Subject: Arkansas Nuclear One - Units 1 and 2
Docket Nos. 50-313 and 50-368
License Nos. DPR-51 and NPF-6
Additional Information In Response To Generic Letter 95-03
(TAC Nos. M92220 and M92221)

Arkansas Nuclear One - Unit 1 Response to Generic Letter 95-03 Request for Additional Information

Arkansas Nuclear One - Unit 2 Response to Generic Letter 95-03 Request for Additional Information

FIGURE 1
DRILLED HOLES IN THE 15TH TSP

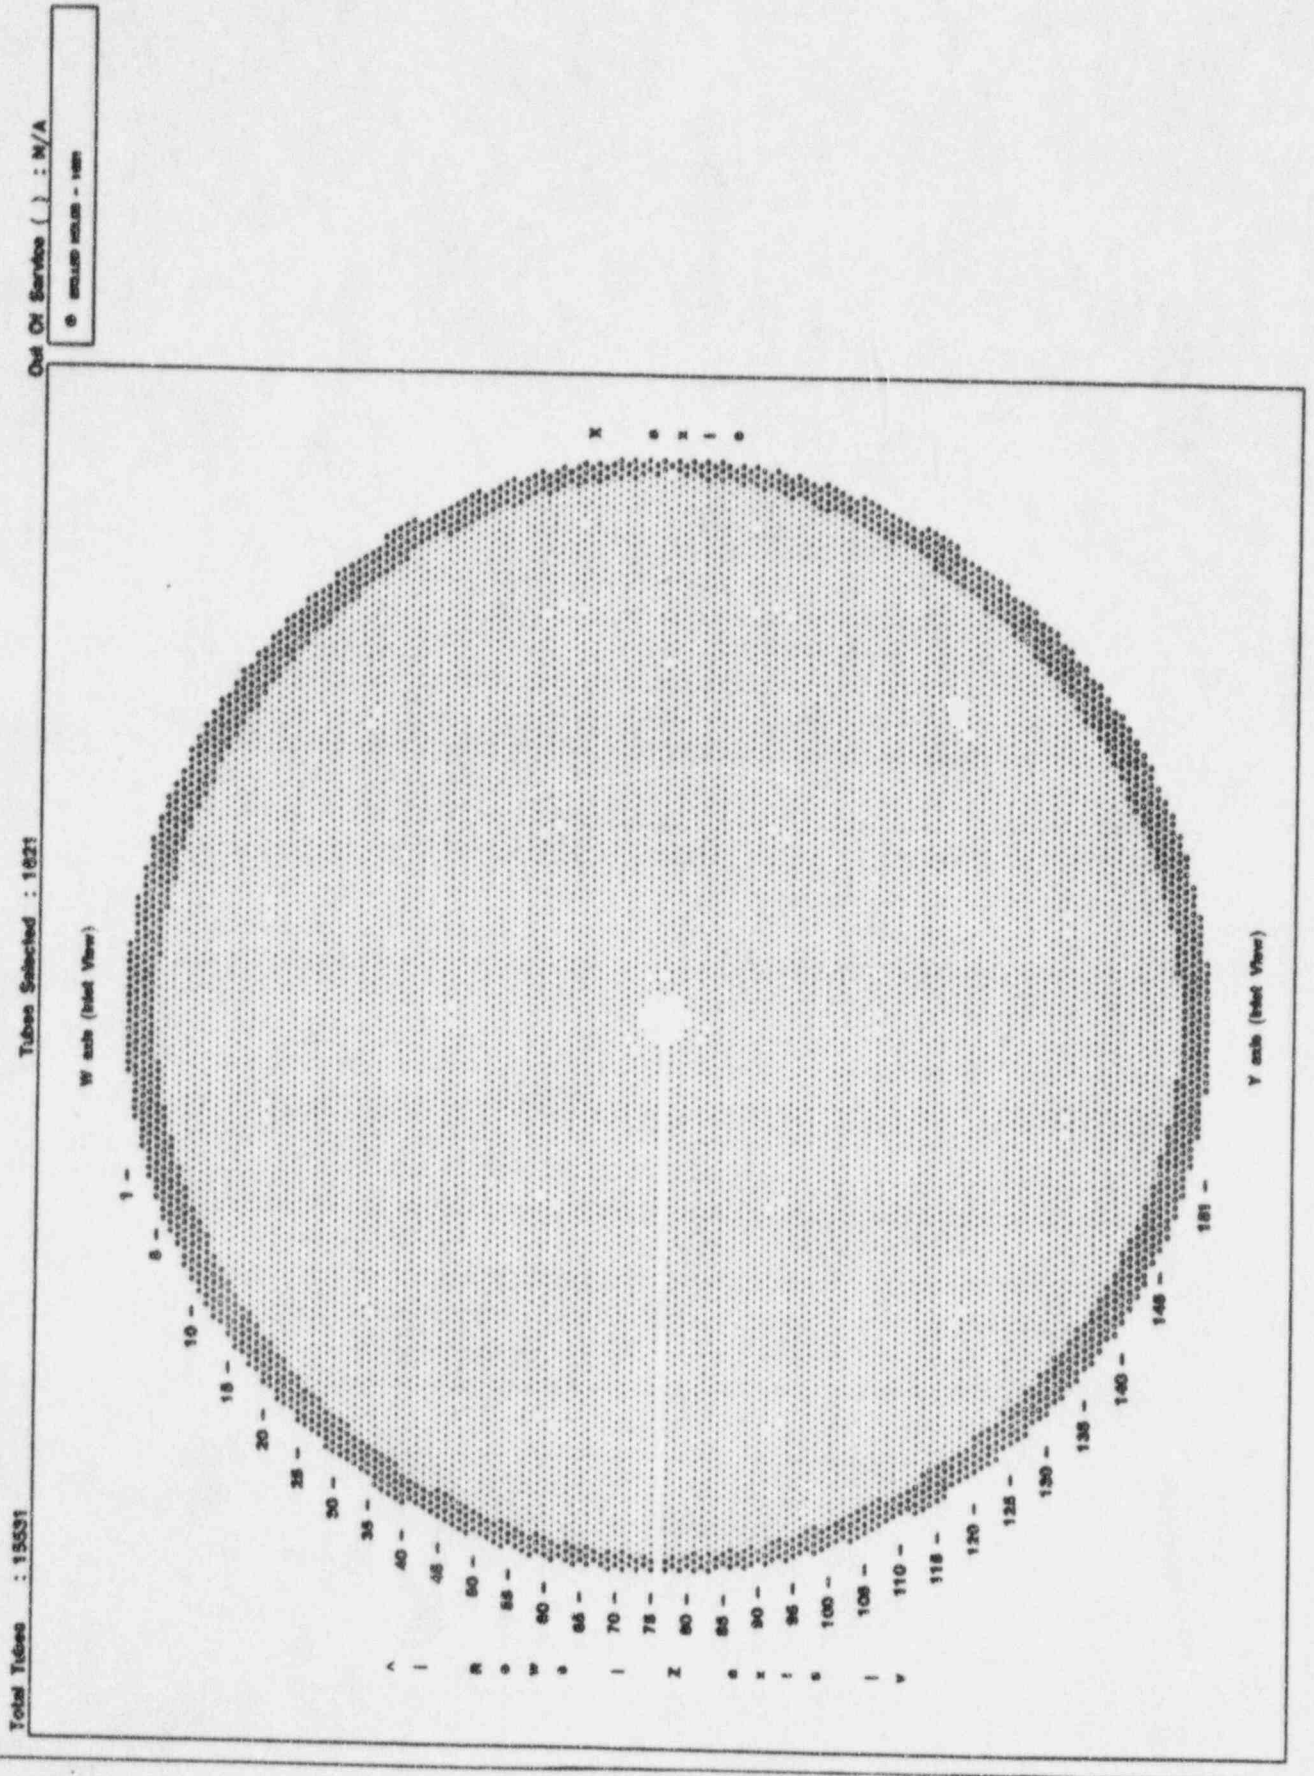
"EPRI report NP-6201 indicates that the fifteenth tube support plate contains both broached holes and drilled holes. The drilled holes being prone to denting. Please clarify whether all of the tube support plates are of the broached hole design or whether a number of them contain drilled holes. Discuss whether denting has been limited to drilled hole locations, if applicable, or if it has been observed at other support plate intersections (i.e., broached holes)."

The 15th TSPs within the ANO-1 steam generators contain both broached and drilled holes. The outer tube locations in the 15th TSP are drilled to a 0.637" minimum/0.646" maximum diameter. 1623 locations are drilled per steam generator as identified in Figure 1. All remaining tube locations within the 15th TSP and all other TSPs are of the broached hole design.

Dings have been detected at both the 15th TSP drilled holes and broached holes. Based upon previous inspection data there does not appear to be a significant preference for the occurrence of dings in the drilled hole locations over the broached hole locations. Growth of observed dings in the OTSGs has been insignificant.
